HTH - Block B doors

Subject: HTH - Notice of Discrepancy N 054 - Block B window alterations

FOR CONSTRUCTION			
PROJECT / DRAWING TITLE Hamsey Town Hall			
DRAWING TITLE RESIDENTIAL BLOCK B North Elevation			
DATE / DRAWN BY 05/07/17 FF		SCALE 1 : 100	
PROJECT NO 3556-KDS-BB-XX-DR-A-05-2001	ZONE 	LEVEL 	REV C3

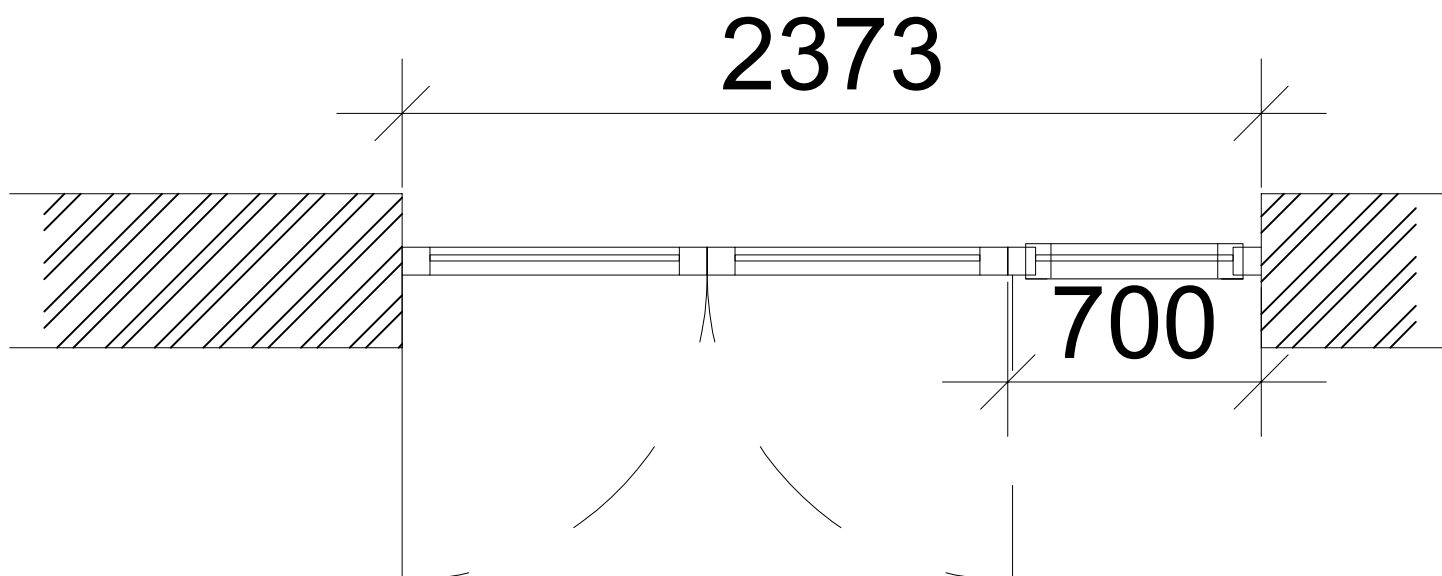
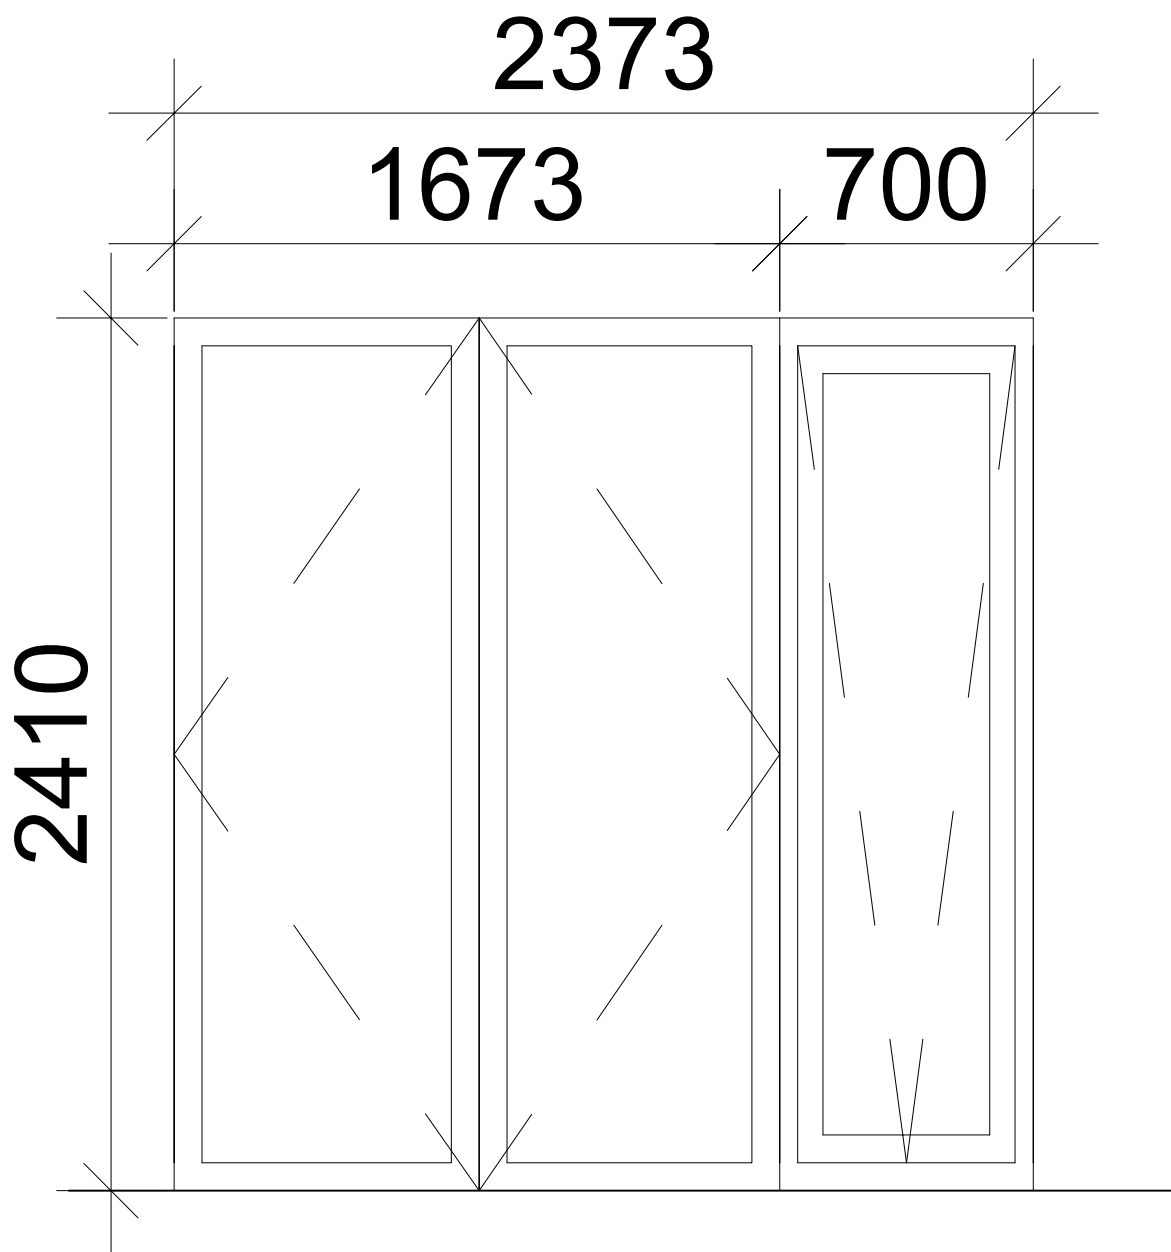
BC COMPLIANT OUTWARD OPENING DOOR WITH SIDE LIGHT (INWARD OPENING WINDOW)

GENERAL REVISION
APARTMENT NSA UPDATED AS PER
KDS-BB-XX-SH-A-07-1050 REV. C1;
INSET BALCONIES WALL LINING TO
BE UPDATED
KITCHEN AND BATHROOM LAYOUT
COORDINATION

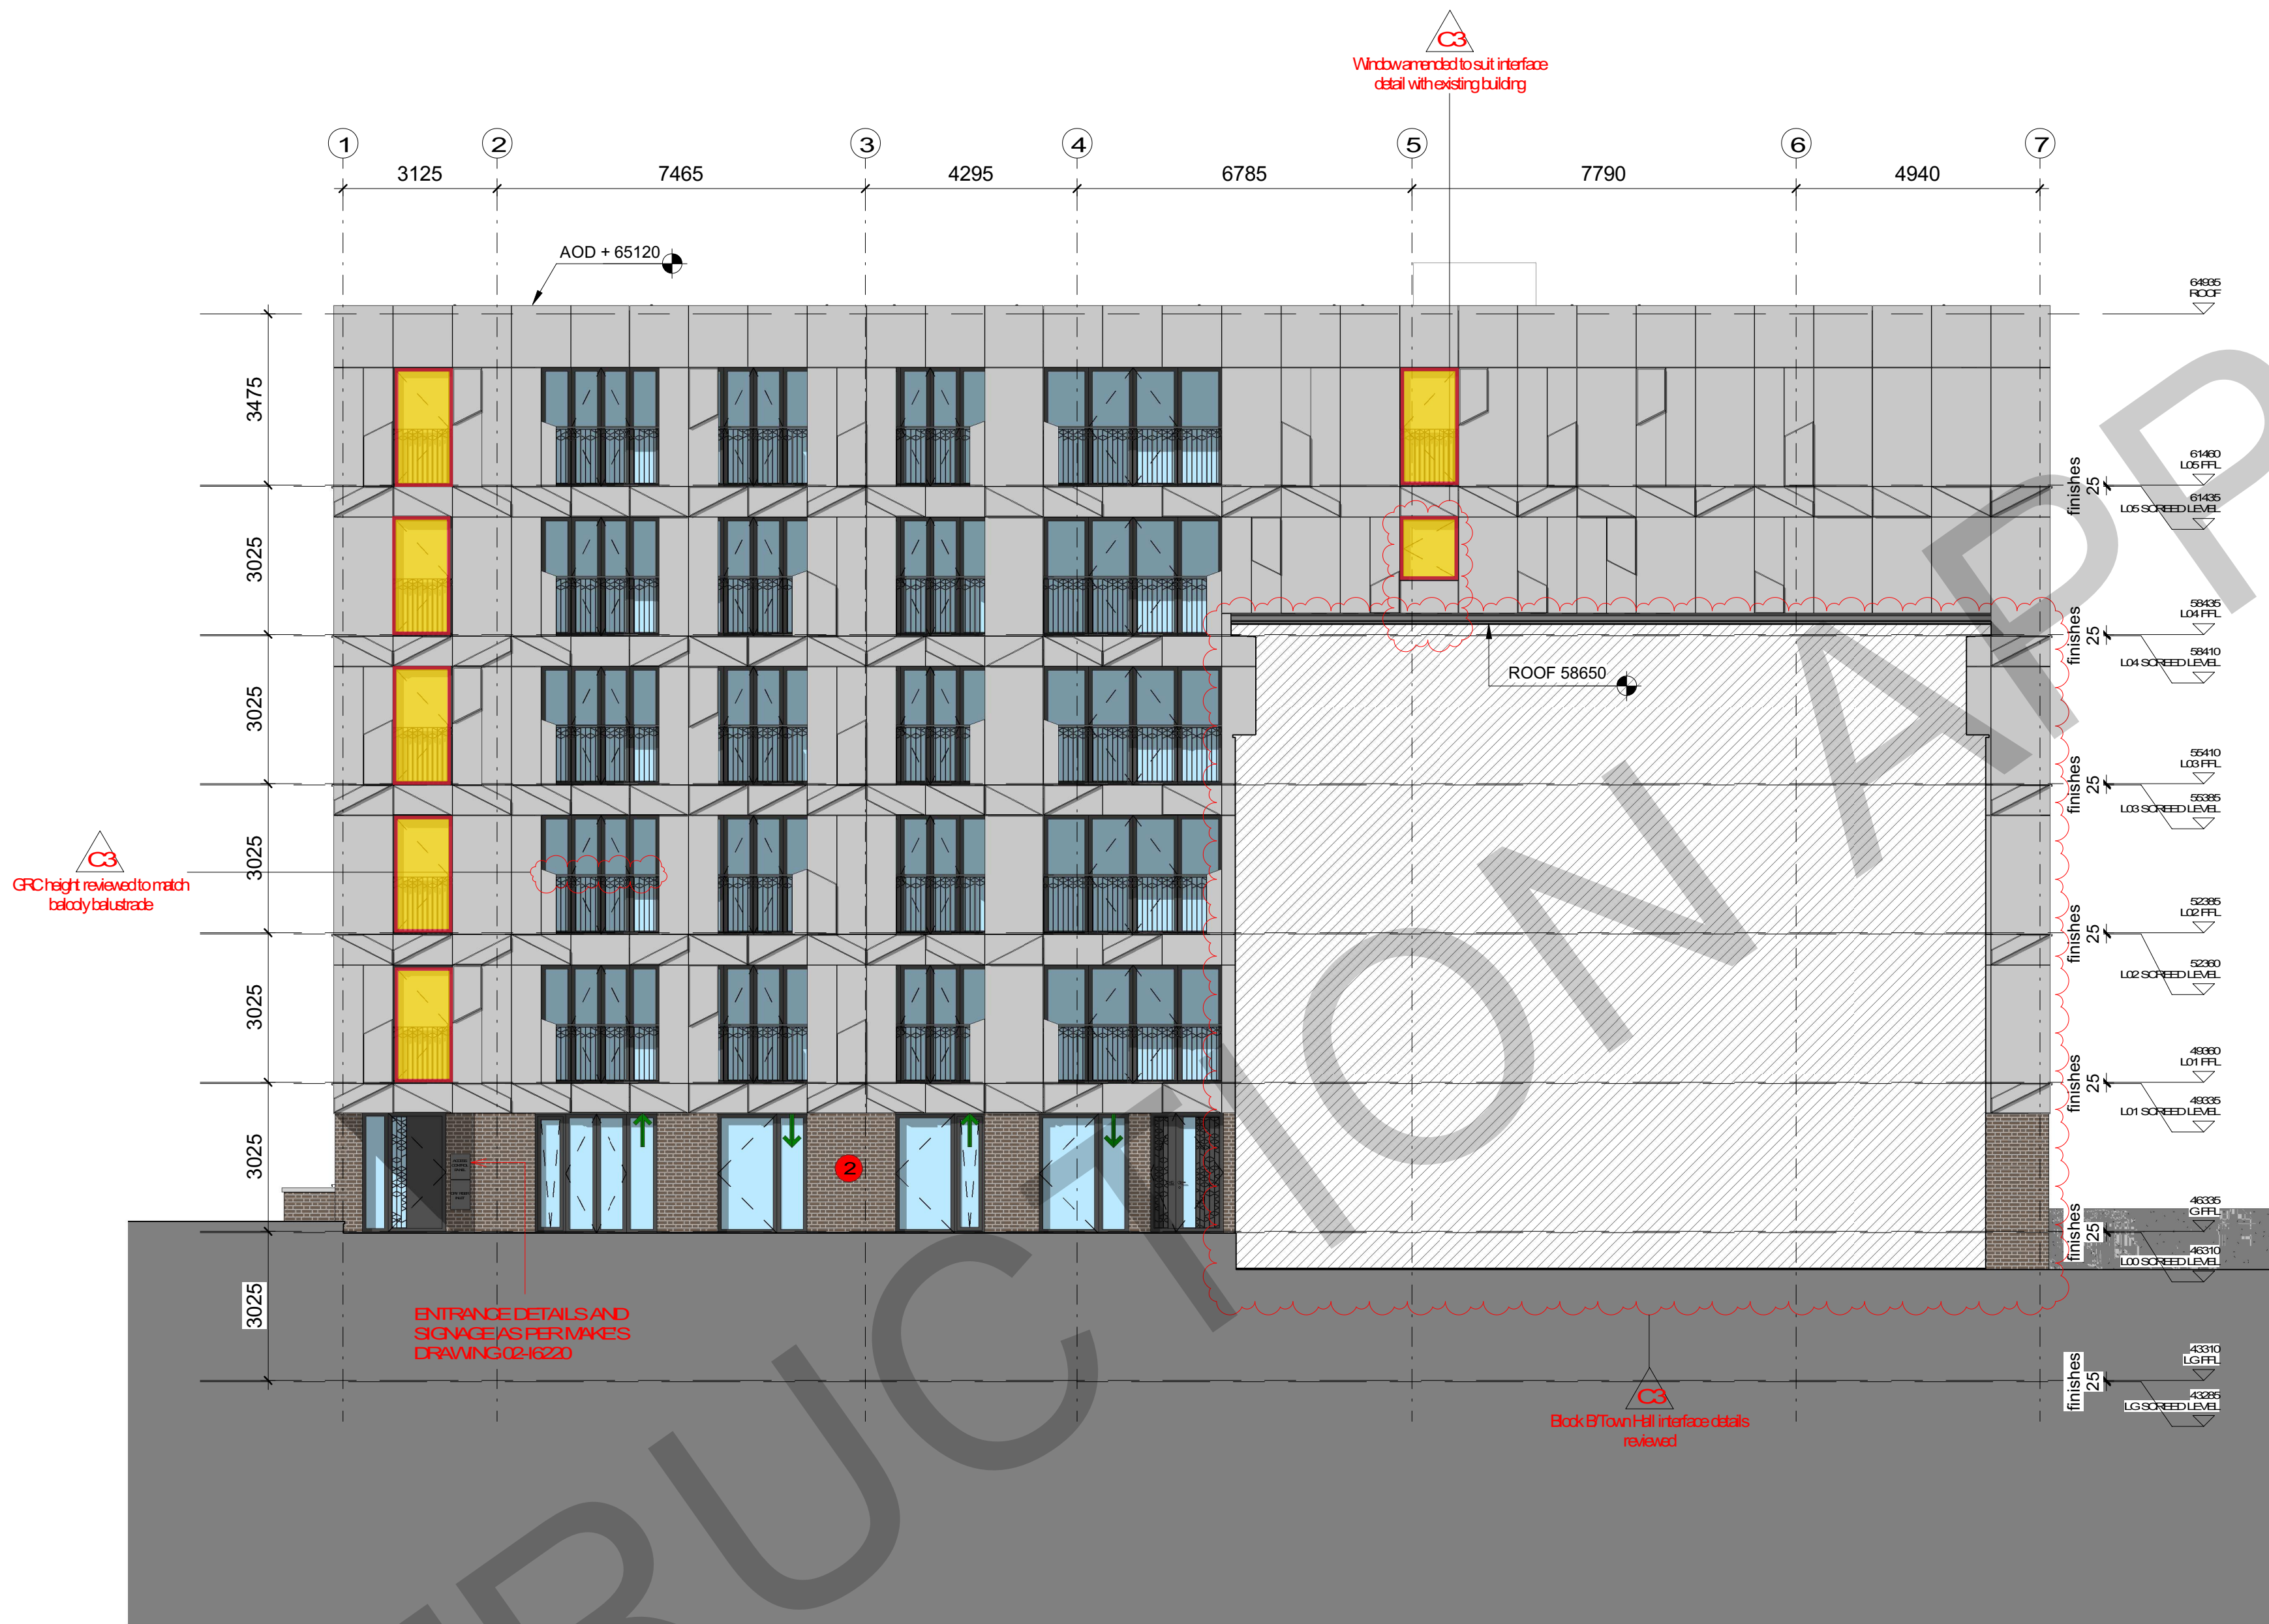
We are having problems with the window sizes of block B due to the weight of glass.

Can you please indicate if we made the doors within the attached mark up into half height windows with top section opening, what does this do to the overheating calculations. The opening transom would be in line with the current balcony height.

Windows / door to have a max frame width 890mm. The window / door will be produced with a factory fitted packer to achieve the ER required S/O widths.
